NETWORK RAIL (HUDDERSFIELD TO WESTTOWN (DEWSBURY) IMPROVEMENTS) ORDER

Calder Road – Design Refinement

Document Reference	151667-TSA-00-TRU-CNT-W-LP-000318
Author	Network Rail
Date	08 November 2021

Phase 5

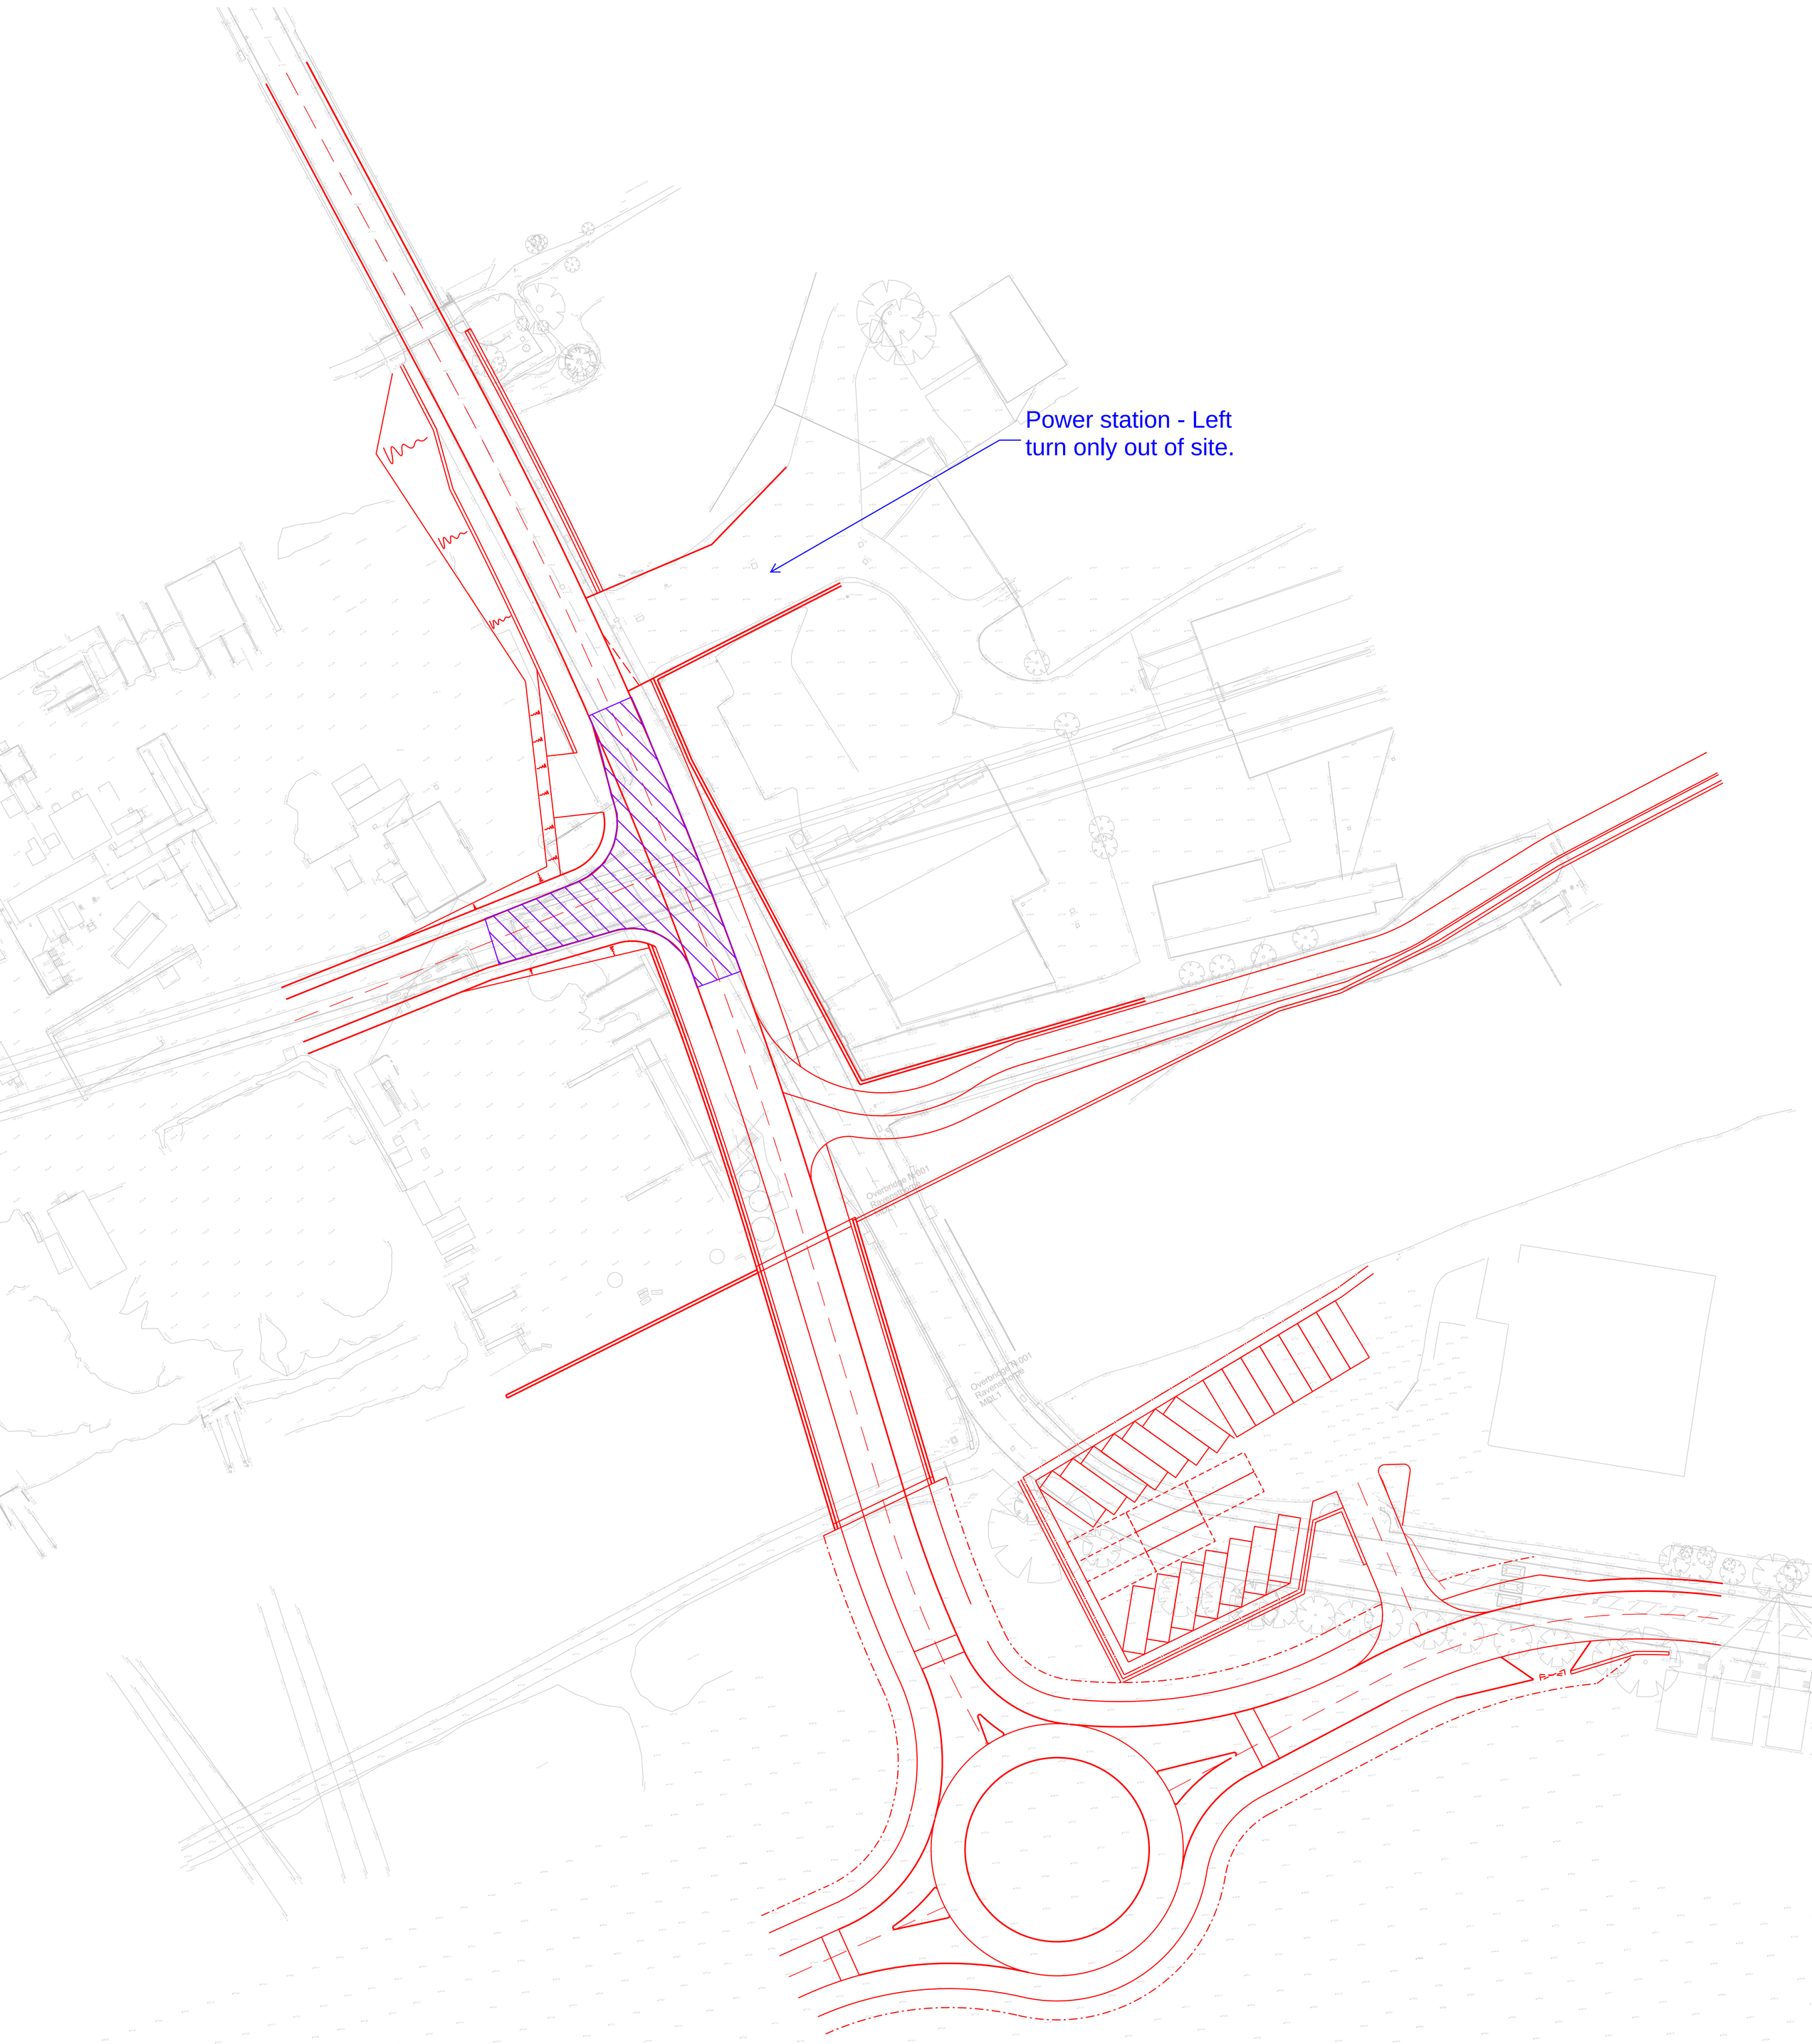
- Reconfigure Newlay Readymix Plant
- Temporary access through Newlay site to construct new rail facing retaining wall along slow line.
- Potential to divert overhead cables.

- Construct rail facing retaining structure, Calder Road bridge abutment and off line highway.
- Traffic management over Calder River bridge - single lane running to allow reconstruction of parapet string course and parapets.

- Close Calder Road river bridge for level raising and resurfacing works
- Weekend opening of river bridge to provide access to the power station while second half of entrances works are completed.
- Lay temporary transition ramps.

- Close existing station access and Calder Road south of Newlay site entrance.
- Construct road between the Phase 1 limit and Newlay site entrance.

- Weekend/ Bank holiday closure of Newlay entrance to allow completion of road raise.

Drawing Title: Newlay Readymix Option 4a

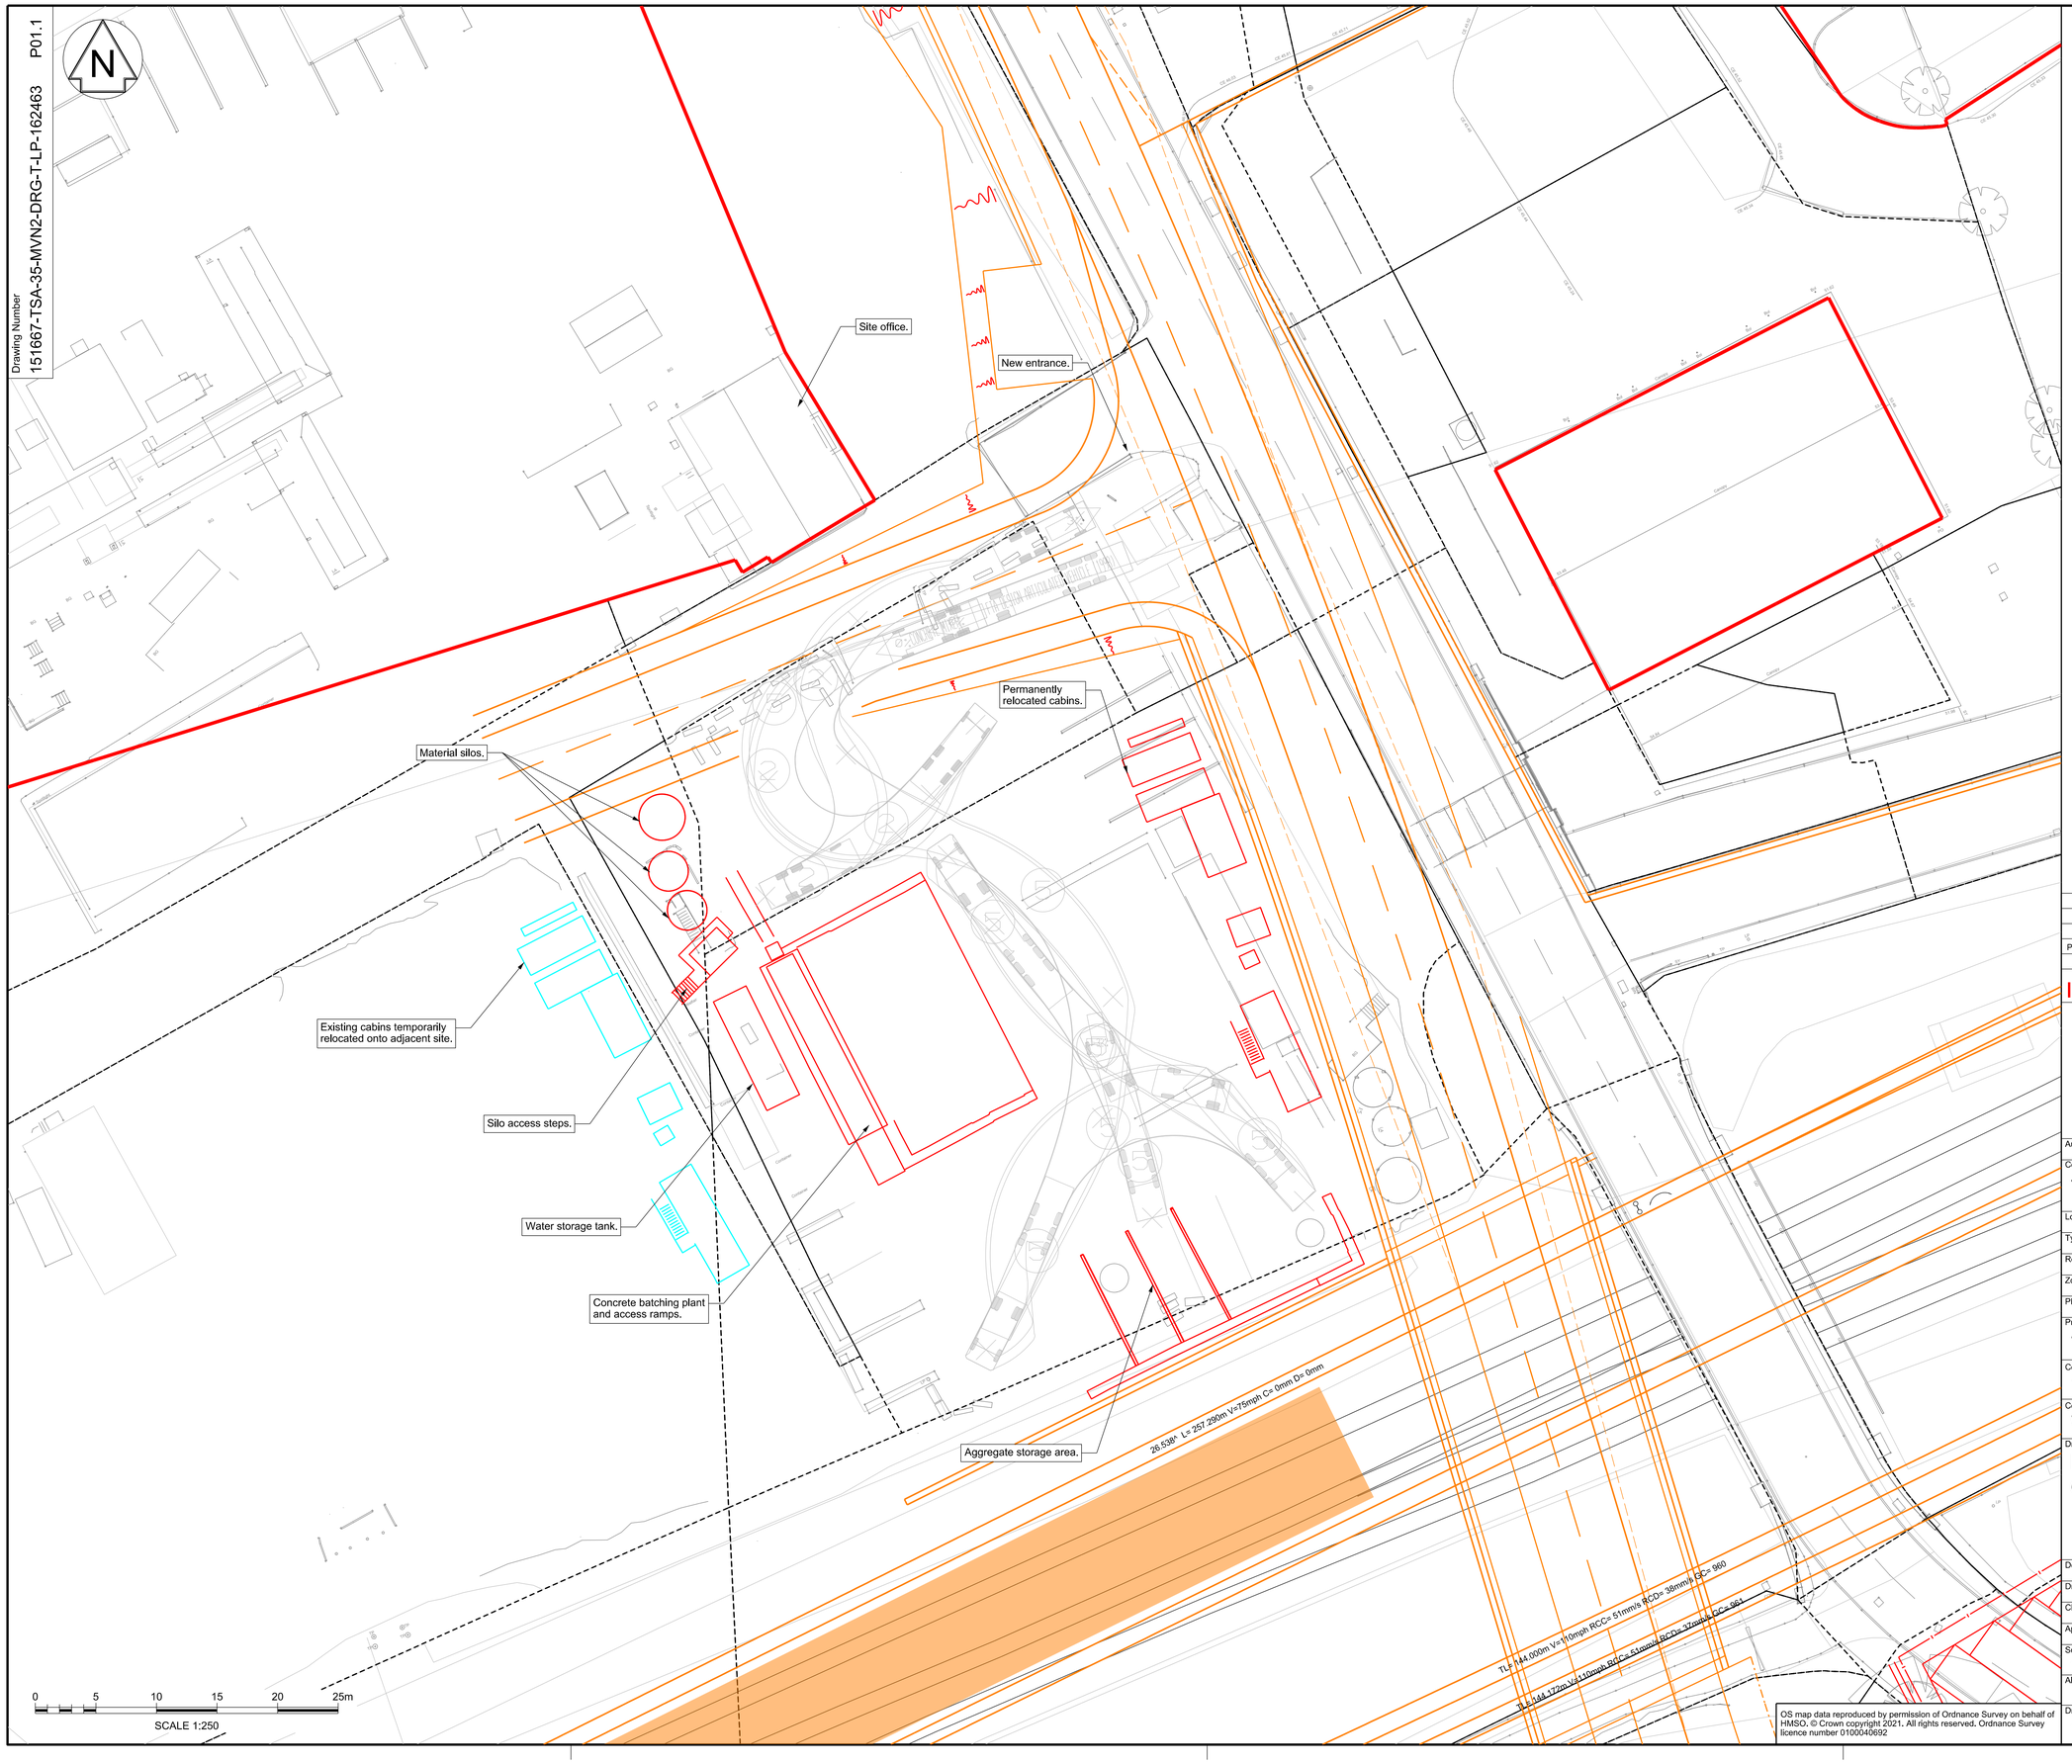
5.2.4 For Option 4A, in the temporary case, the key pieces of equipment would be relocated to the west side of the footprint of the existing Newlay Readymix facility, retaining its existing configuration with respect to the positioning of the ancillary equipment (e.g. silos and conveyor). The aggregate storage would be relocated to the southern boundary. The remainder of the facilities, including the offices and other storage areas, would be relocated to west (onto the Northern Powergrid land) on a temporary basis, and would then be relocated back adjacent to the realigned Calder Road on a permanent basis.
